**Addendum No. 1
to the Bidding Documents for**

BID PROPOSAL #09-15

**Hobbs Hill Water Tank Replacement
City of Portsmouth Department of Public Works
Portsmouth, New Hampshire**

Issued September 8, 2014

TANK ELECTRICAL PLAN
NO SCALE

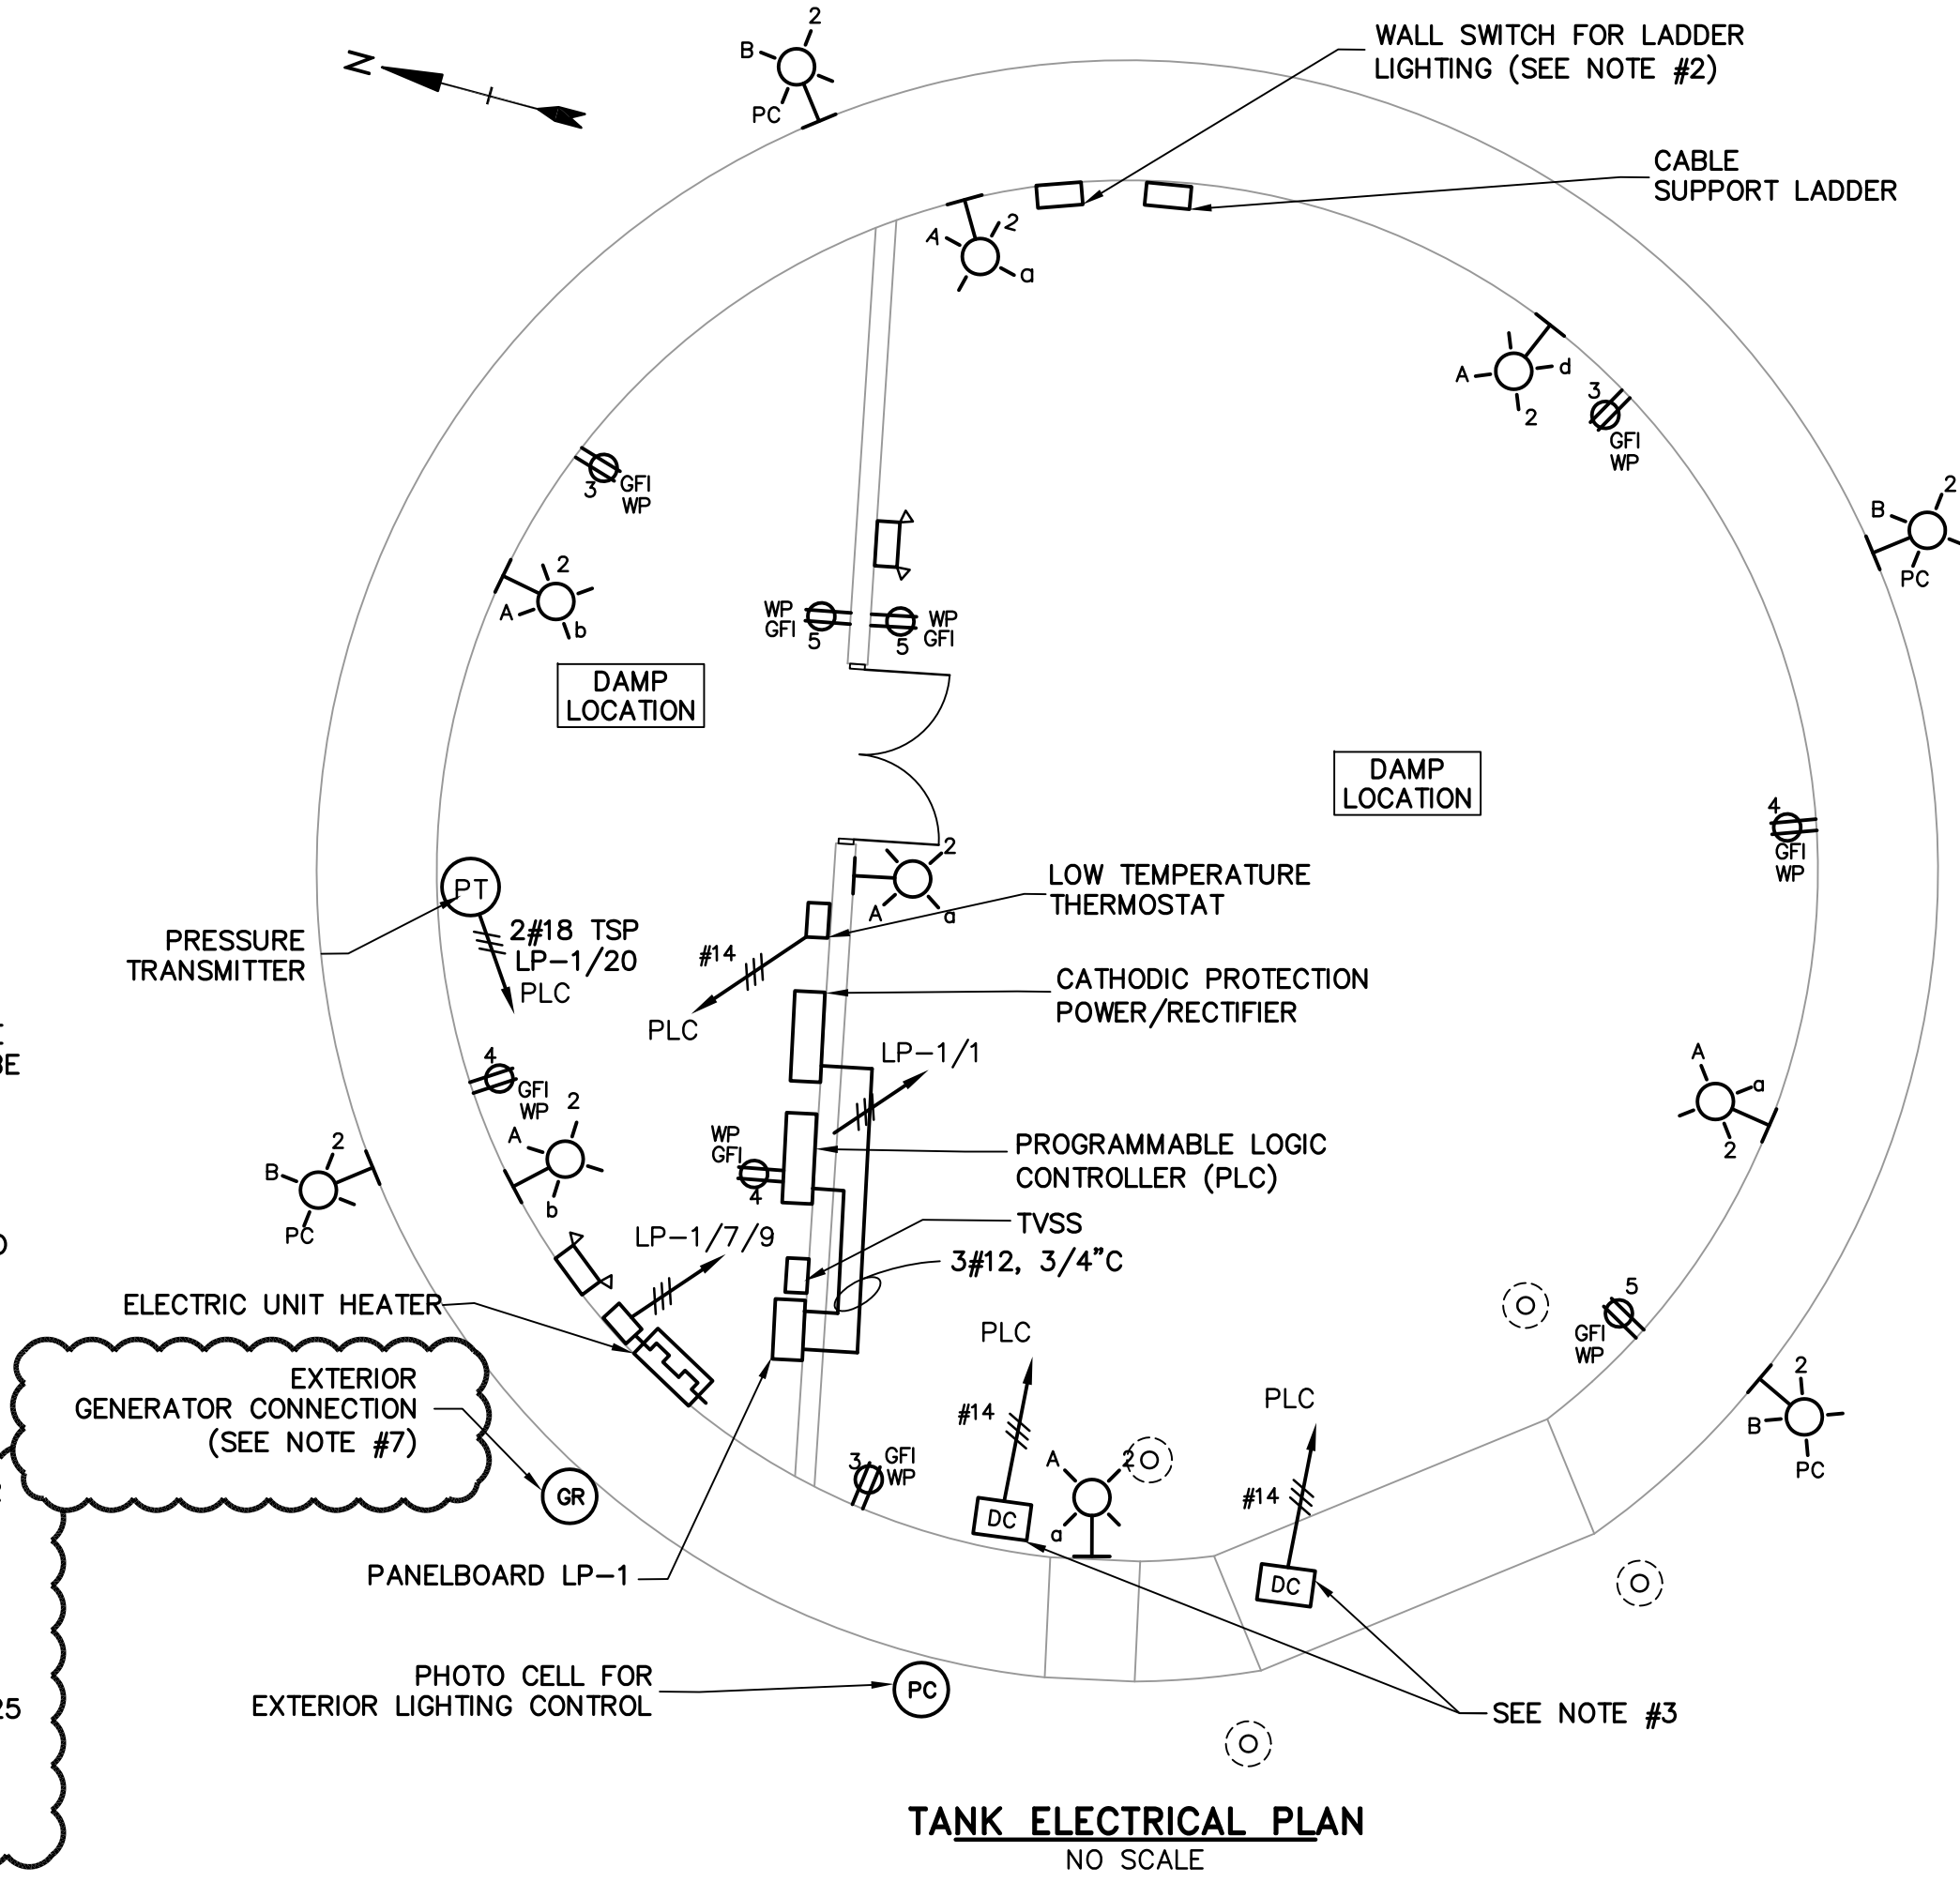
8. Are there details for mounting brackets necessary for the antennas (Sheet 10, Tank Antenna Layout Plan)?

31. Page 13210-14 specifies a 10'x10' overhead door as does drawing sheet 6. Drawing sheet 10 specifies a 12'x12' overhead door. Please clarify door size.

The mounting brackets for railing mounted antennae will be provided by the contractor relocating the antenna. The locations of the railing mounted antenna were provided to ensure that the railing/tank design takes into account the loads associated with them. The mounting brackets for the tank mounted antennae will be furnished and installed by the contractor relocating the antennae. The timing of installation and final location for antenna support bracket fabrication will need to be coordinated with the antenna contractor prior to painting. The locations of the tank mounted antenna were provided to ensure that the structural design takes into account the loads associated with them.

The overhead door size shall be 10 feet by 10 feet.
